ACCESS DESIGN REVIEW – SSDA MODIFICATION

S5 - 269 Lane Cove Rd, Macquarie Park

Revision: ADR 1.0

Date: 9 October 2025

Drawing title
GENERAL ARRANGEMENT PLAN - BLD A AND OFFICE - GROUND FLOOR LEVEL

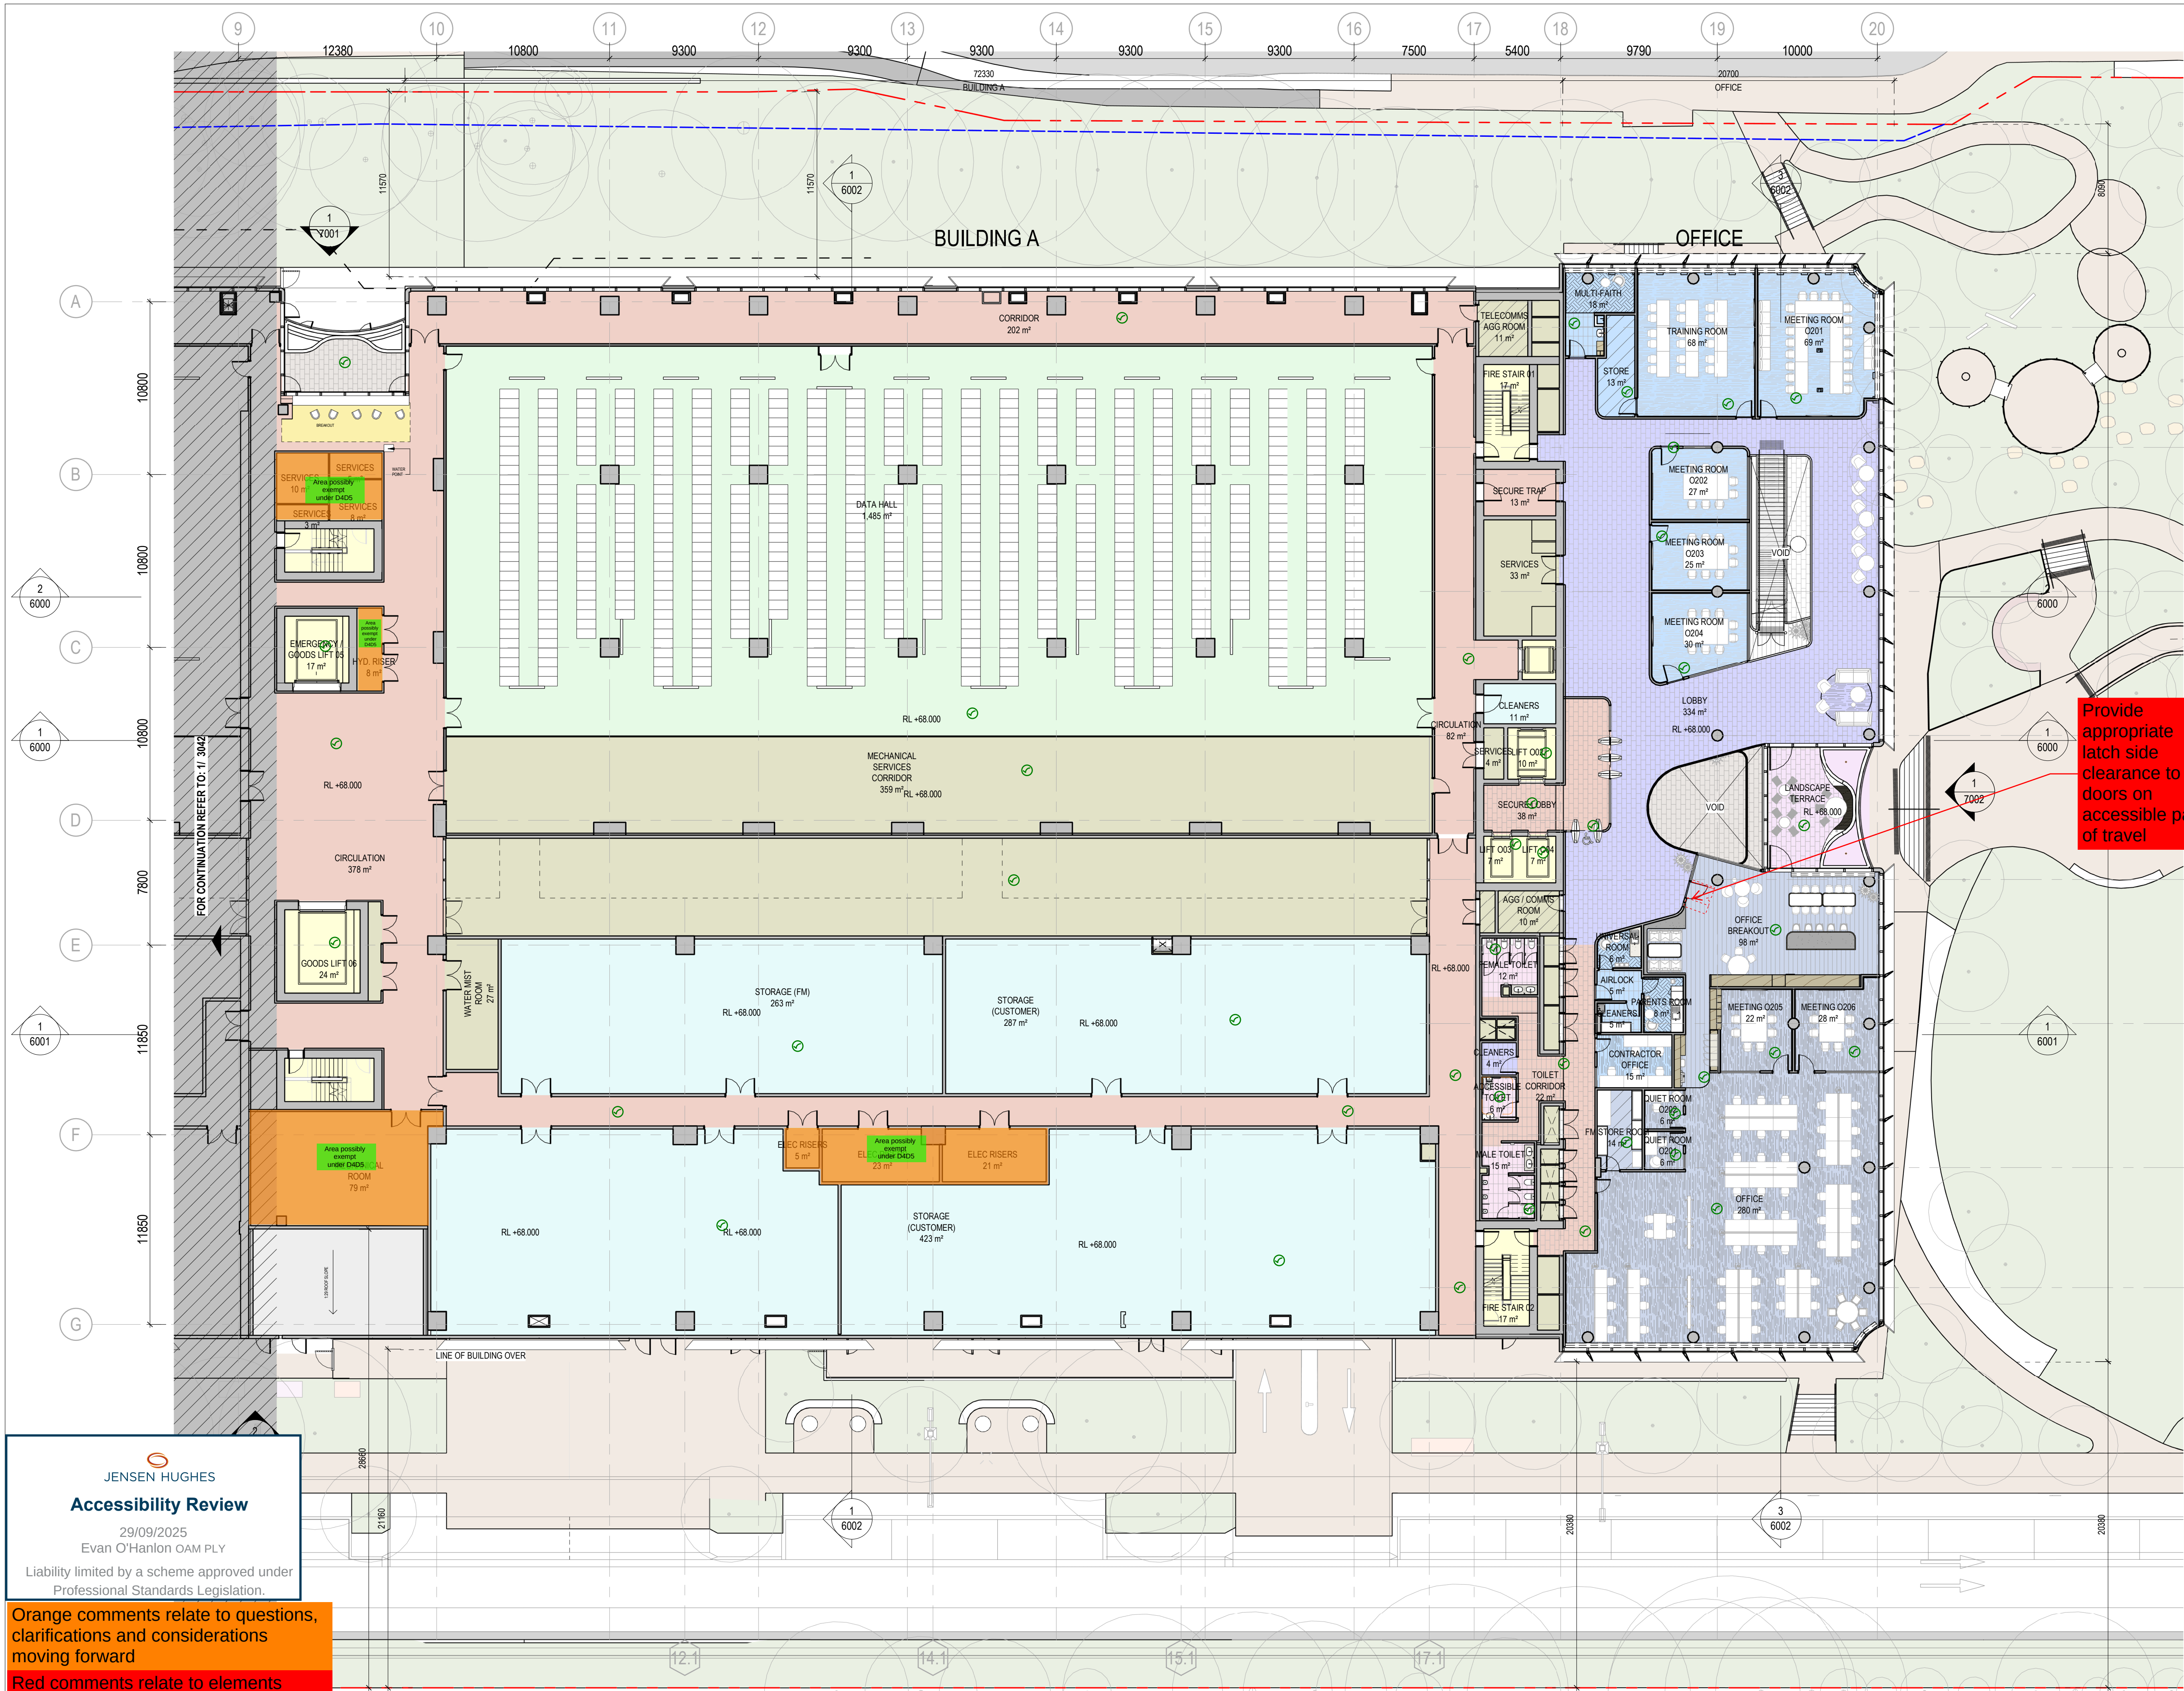
Ensure even number of left hand (LH) and right hand (RH) transfer WC pans (accessible toilets) is required within the building. Alternate LH/RH layouts on each subsequent level.

Provide appropriate latch side clearance to all doors on accessible path of travel

Out of scope: Possibly require BCA Psol for unisex ambulant WC

Refer to Landscape drawings for comment
